Model: Sirius-PJ1nx/nw		Date: 01-Feb-12	No.: RY013001
Subject: Parts Catalog Correction		Prepared by: K.Nakano	
From: 2nd Tech Service Sect., MFP/P Tech Service Dept.			
Classification:	<input type="checkbox"/> Troubleshooting <input type="checkbox"/> Mechanical <input type="checkbox"/> Paper path <input type="checkbox"/> Product Safety	<input checked="" type="checkbox"/> Part information <input type="checkbox"/> Electrical <input type="checkbox"/> Transmit/receive <input type="checkbox"/> Other ()	<input type="checkbox"/> Action required <input type="checkbox"/> Service manual revision <input type="checkbox"/> Retrofit information <input type="checkbox"/> Tier 2

Model: Sirius-PJ1nx/nw		Date: 23-Jul-12	No.: RY013009
Subject: Remote mouse receiver is added as a service part.		Prepared by: K.Nakano	
From: 2nd Tech Service Sect., MFP/P Tech Service Dept.			
Classification:	<input type="checkbox"/> Troubleshooting <input type="checkbox"/> Mechanical <input type="checkbox"/> Paper path <input type="checkbox"/> Product Safety	<input checked="" type="checkbox"/> Part information <input type="checkbox"/> Electrical <input type="checkbox"/> Transmit/receive <input type="checkbox"/> Other (

Page 4 of the Parts Catalog:

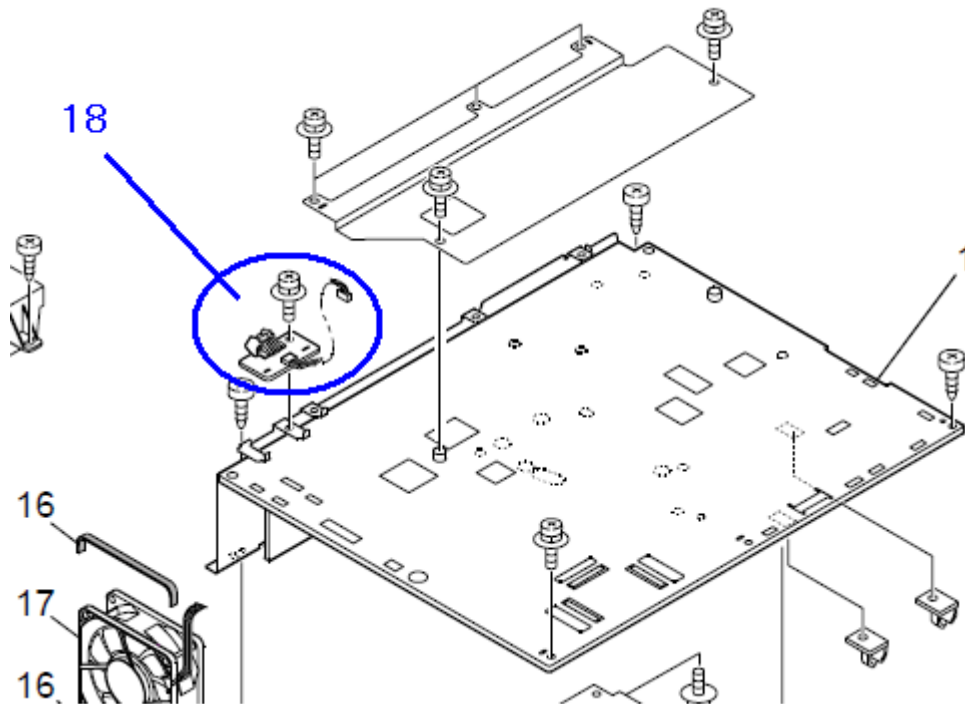
The following parts are added.

New part #	Description	Q'ty	Int	Page	Index	Note
Y0131181	SAFETY SWITCH:LAMP	1	-	3	21	
Y0135067	PCB:REMR:ASS'Y	1	-	5	18

Page 2 in Parts Catalog (The added part is highlighted in red):

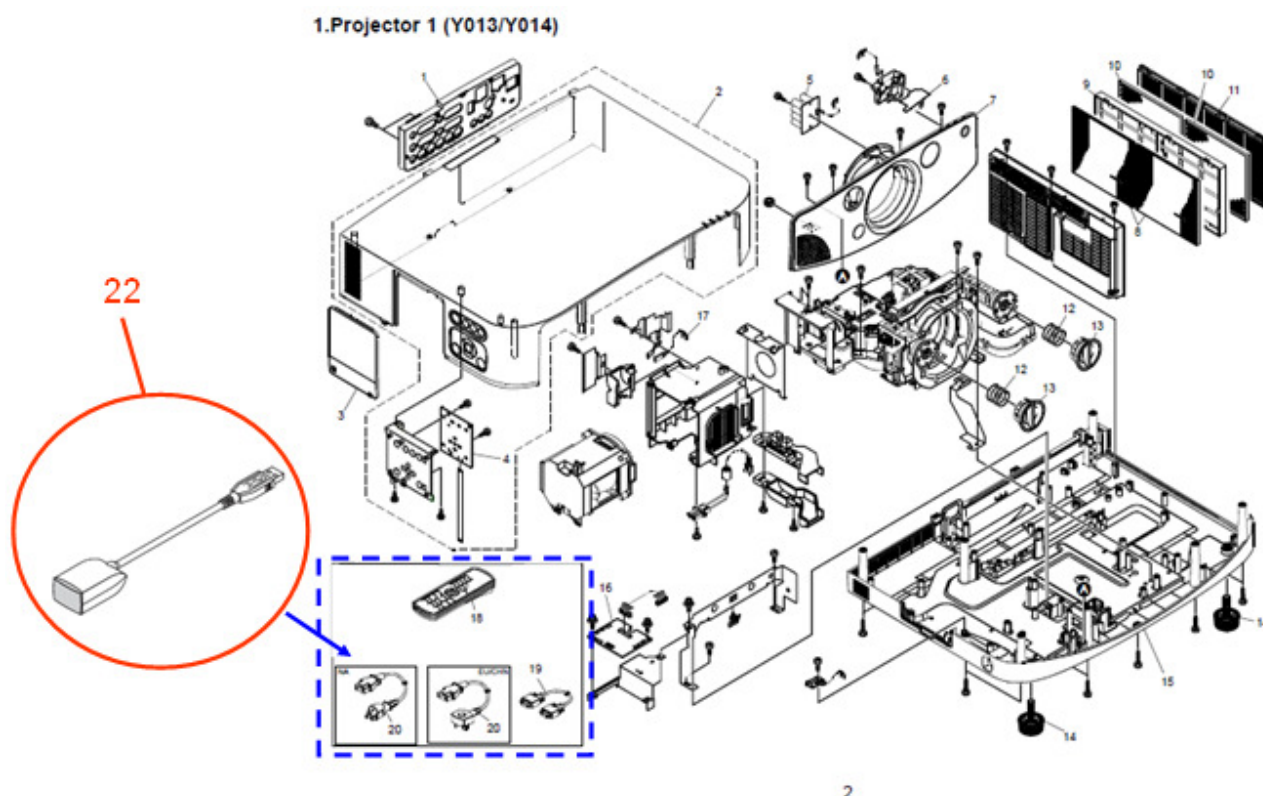
The following part is added:

New part number	Description	Q'ty	Int	Page	Index	Note
Y0156095	Remote Mouse Receiver	1	-	3	22
